Comments on Milton Keynes East Strategic Urban Extension 21/00999/OUTEIS

From MK Green Party

2.11.21

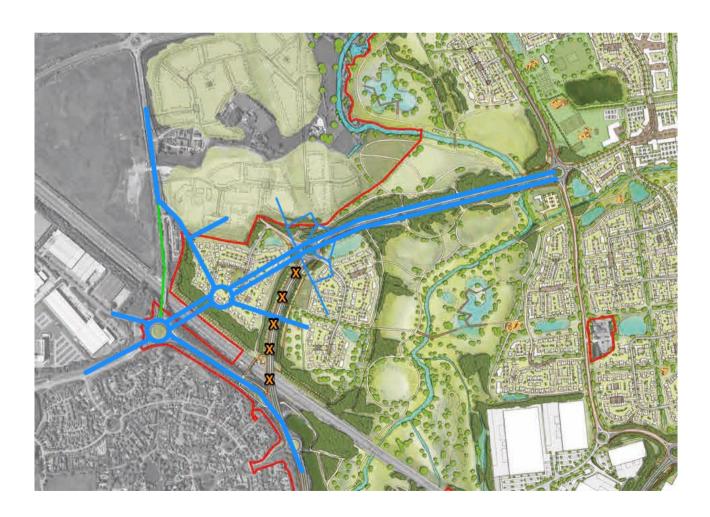
At the proposed dive-under Y junction on the V11 near Carleton Gate there will be no access for traffic from east to west or vice versa. Consequently all east-west traffic traffic on the H4 alignment will have to use Willen Rd and the Bloor district distributor road. Neither of these roads is a grid road. The Bloor district distributor road is not suitable for the amount of through traffic that it will have to handle, especially with houses fronting on to it. The junction of Willen Rd and the Bloor district distributor road will be a T-junction. This will be a cause of delays and congestion, with or without signals, because of the amount of traffic turning at the junction.
